August 22, 2007

SUBJECT: STAFF EVALUATION OF BWRVIP RESPONSE TO NUCLEAR REGULATORY COMMISSION SAFETY EVALUATION OF "BWR VESSEL AND INTERNALS PROJECT, EVALUATION OF CRACK GROWTH IN BWR STAINLESS STEEL RPV INTERNALS (BWRVIP-14-A)" (TAC NO. MC2738)

Figure 2. Times for Growth to 0.8h for Three Different Distributions of Stress Intensity Factor.

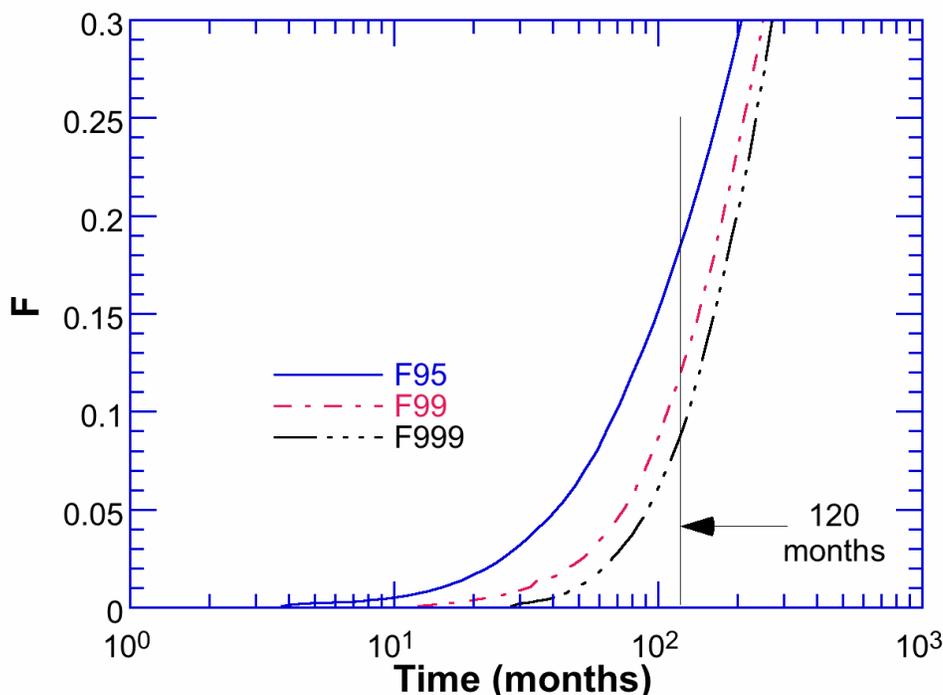
To compute F , the distribution of stress intensity factors is assumed to be characterized in terms of the distribution of times required to grow a flaw from 0.1h to 0.8h (where h is the wall thickness) for a given crack growth rate, which is taken as the BWRVIP "95th percentile" growth rate. This distribution is assumed to be log-normal with the time corresponding to the BWRVIP-14-A generic K-distribution as the median, and the time corresponding to the H6a K-distribution as a high percentile. This percentile value is chosen to make the likelihood of through-wall growth consistent with field experience. The crack growth rate is also assumed to be distributed normally with a 95th percentile value similar to the BWRVIP-14-A crack growth rate model and the 5th percentile value an order of magnitude lower.

Monte Carlo calculations were performed by taking a sample from the failure time distribution and a sample from the crack growth rate distribution, and using the crack growth rate value to scale the time sample (which was computed using the BWRVIP crack growth rate 95th percentile correlation). The Monte Carlo samples can then be rank ordered to estimate the probability of failure, i.e., growth to 0.8h, by a given time. Calculations are shown in Figure 2 for cases where the time for growth to 0.8h corresponding to the H6a stress intensity distribution is taken as the 95th, 99th, and 99.9th percentile value of the distribution. For the 95th percentile case, the probability that the crack has grown to 0.8h through-wall is 0.17 and the probability that no cracking this deep would have occurred in any of the 26 cases is 0.007.

This is too low to be statistically plausible. For the 99th percentile case, the probability that the crack has grown to 0.8h through-wall is 0.11 and the probability that no cracking this deep has occurred is 0.05. While low, this is considered statistically possible and the conclusion is that the H6a K-distribution represents the 99th or higher percentile of the K-distributions observed in service. The value of [] months for the BWRVIP-14-A generic K-distribution and 95th percentile crack growth rate corresponds to the 25th percentile of the F99 distribution. Thus it would give conservative answers greater than 75 percent of the time. The crack depth would exceed 0.8h less than 11 percent of the time.

These results support the assertion in the BWRVIP letter dated September 12, 2005, that the combination of the BWRVIP-14-A generic K-distribution and the BWRVIP 95th percentile crack growth rate curve will provide reasonably conservative estimates of through-wall growth of cracks even though they may not be bounding in all cases.
